ADDENDUM NO. 03

Northland Corridor Redevelopment Project Phase 4
631 Northland Ave.
Buffalo, NY 14211

Project No. 432607

Project Northland Corridor Redevelopment Phase 4 (BUDC) Addendum No. 3
631 Northland Avenue, Buffalo, NY Contract -
Wendel Project No. 432607 Date 10/22/25

C201

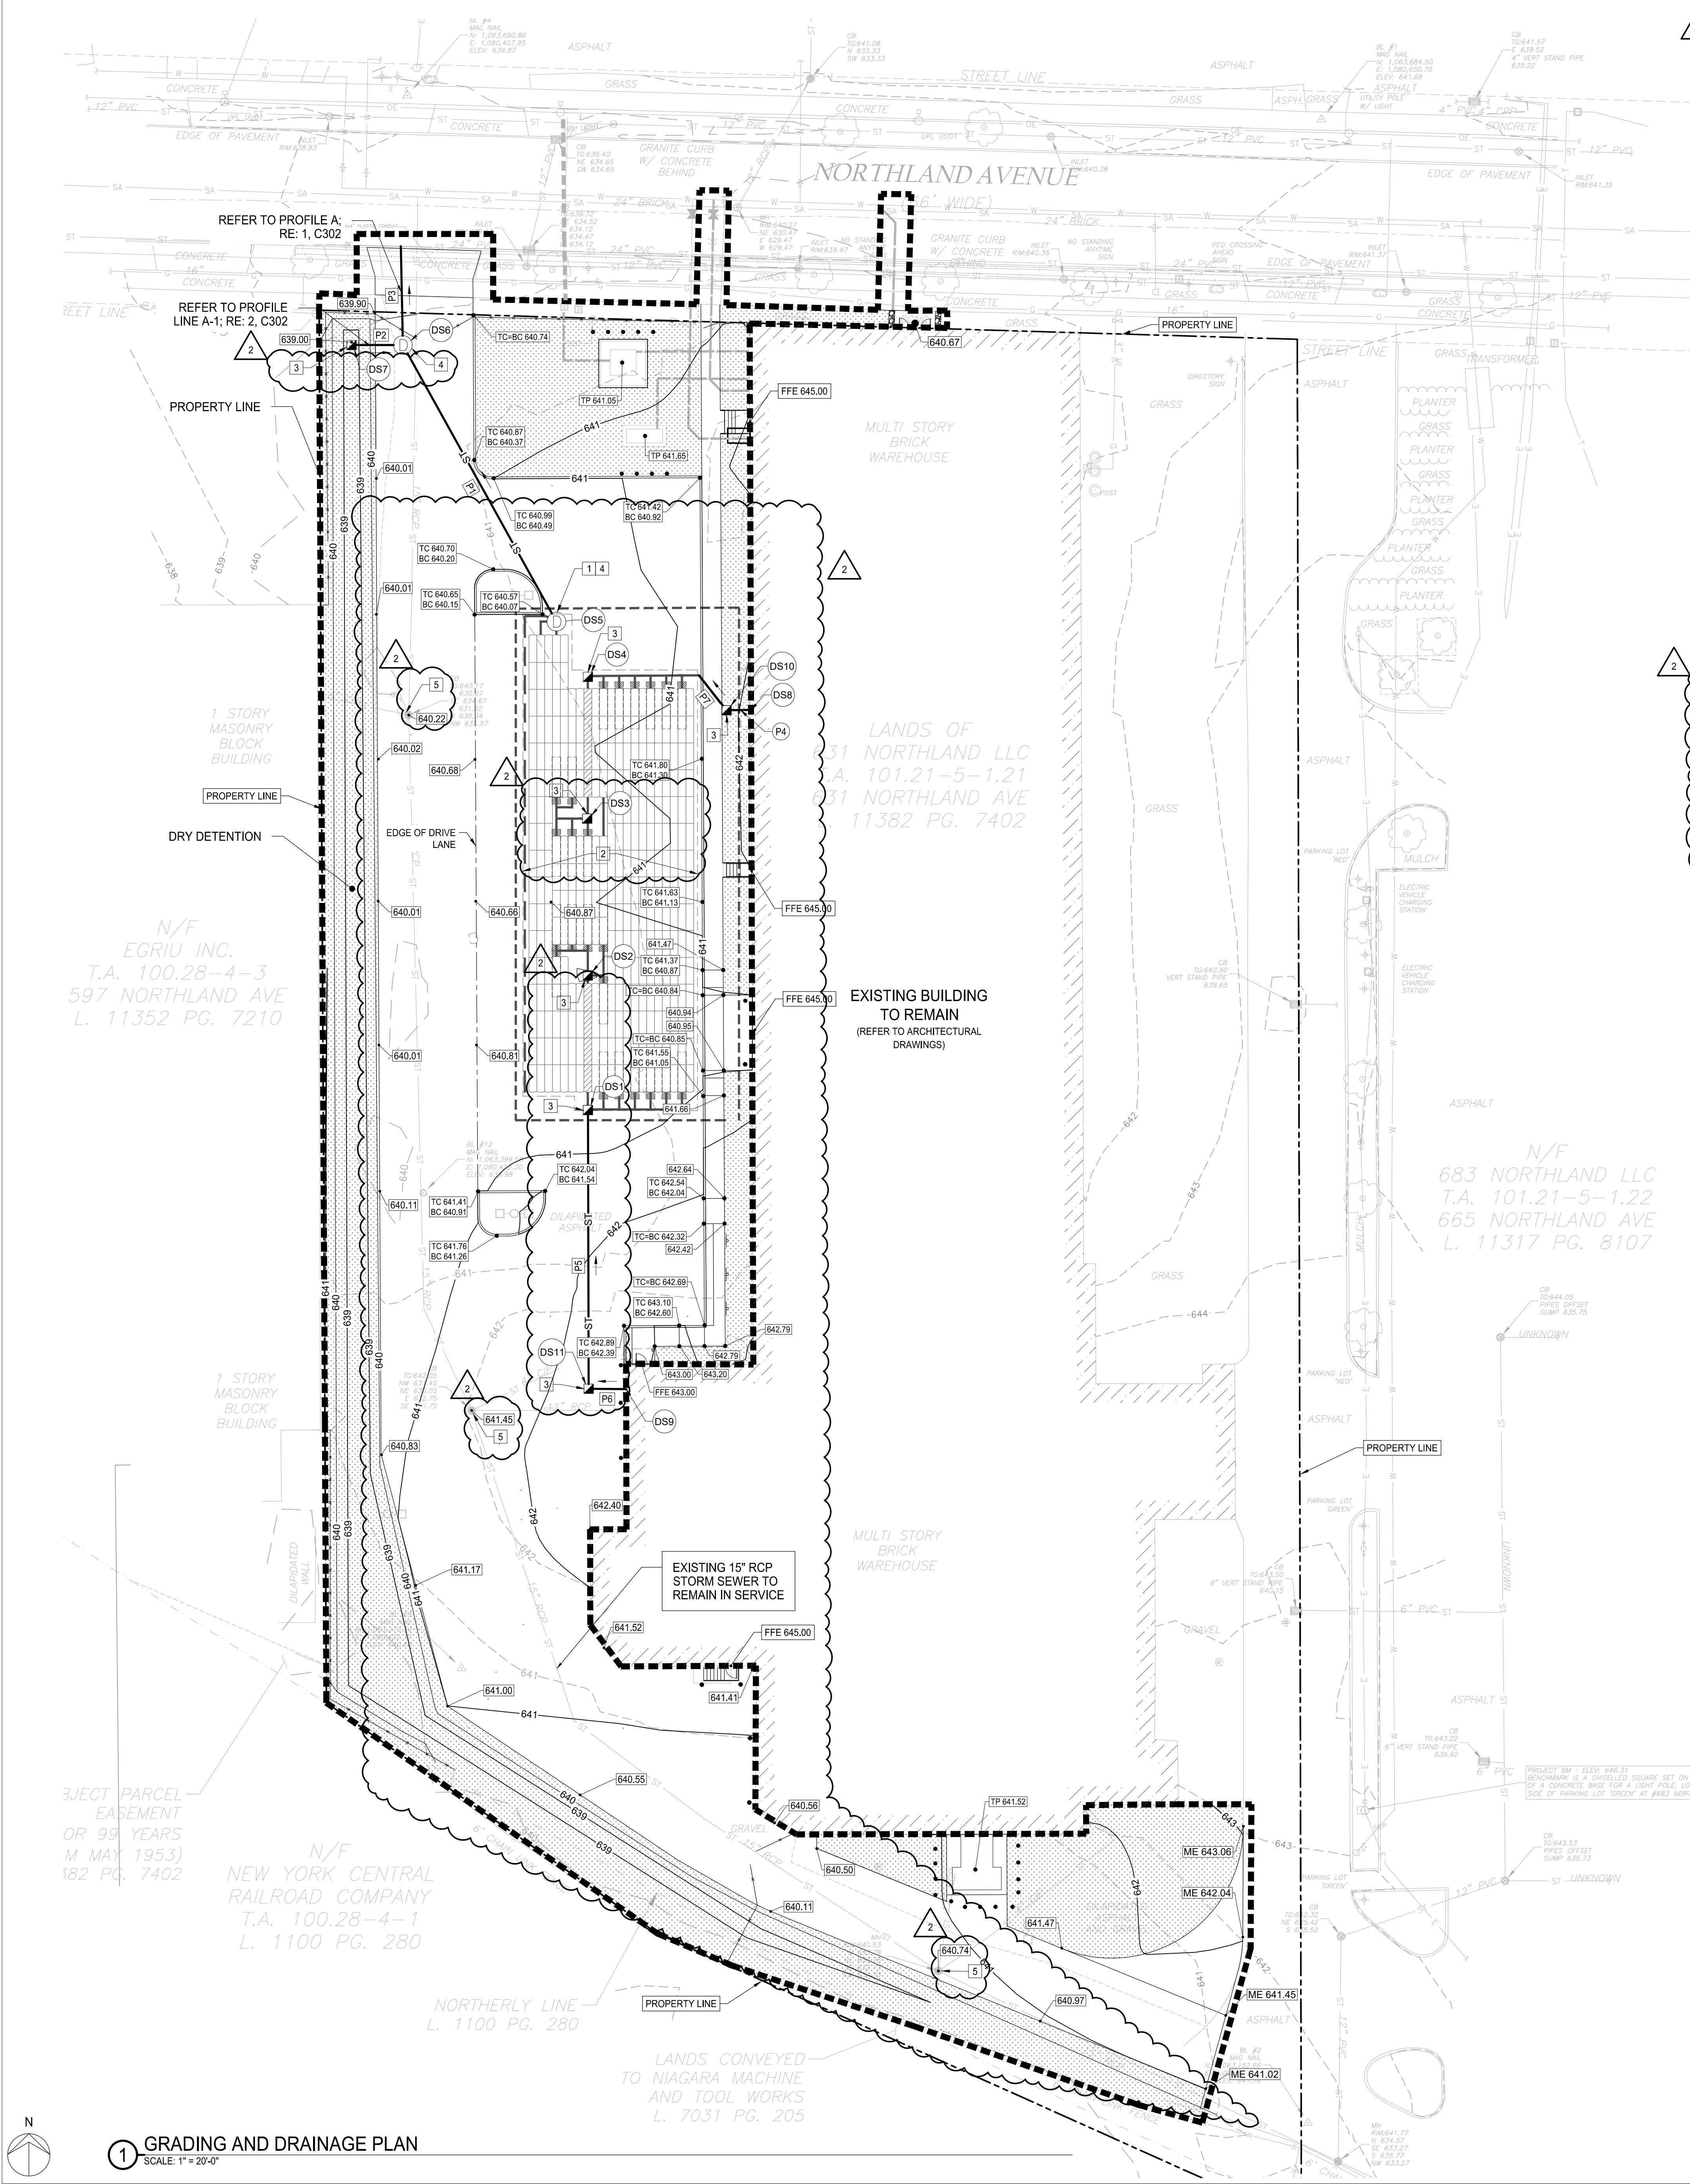
CLARIFICATION: Revisions in the above referenced sheets accommodate environmental requirements and provide clarification to utilities, drainage, and grading.

ADD: Revised civil drawings C102, C103, C201, C301, C302, C503, C504 issued as part of this addendum.
